Correspondence Reference Number: 12237
Confirmation Number: EA96089
FCC ID: MIJTELCPE-USB-01

To: Errol Chang
From: Jim Dykema

Subject: Request for technical data

Figure 1 16 QAM data carrier at 31.2256 GHz compared to digital emission mask (101.111(a)(2)) – closeup of band edge

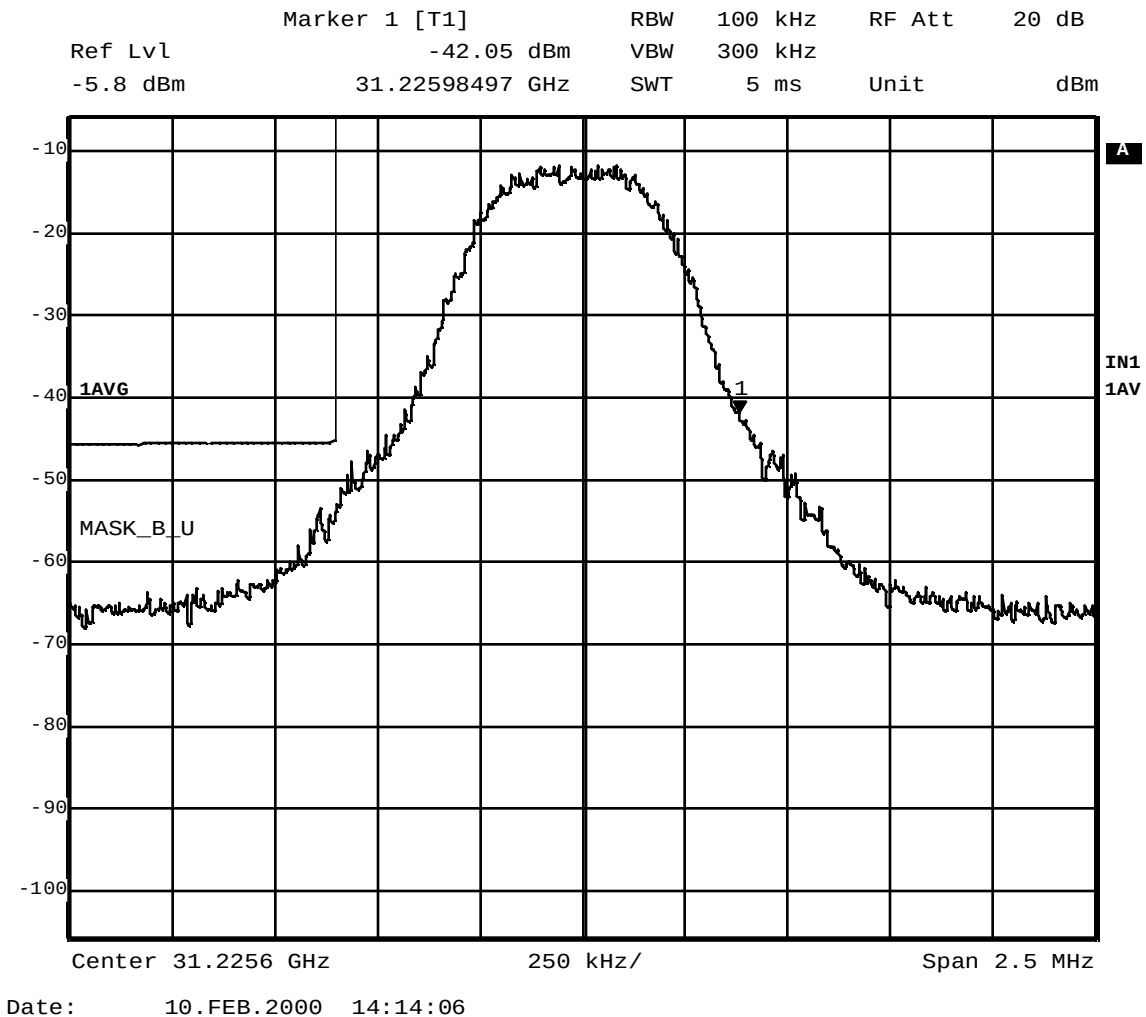
With regards to the calculation of the emission mask, your letter states that “ the emission limit at the LMDS band edge starts at - 29.75 dB and continues on a slope to - 56 dB at the frequency of 86.25 MHz removed from the band edge and stays there until 187.5 MHz removed from the LMDS band edge”. While I agree with your figures of - 29.75 and -56 dBc, I was under the assumption that the 86.25 and 187.5 MHz frequencies were relative to the allocated band center frequency and independent of carrier frequency.

The above figure shows that the peak of the unmodulated signal was measured at -5.8 dBm. The limit for the digital emission mask at 50% removed from the allocated band center is 29.75 dBc. The bandwidth correction for 100 kHz RBW is -10 dB. Therefore, the mask is at -45.55 dBm (-5.8dBm - 29.75dBc - 10dB).
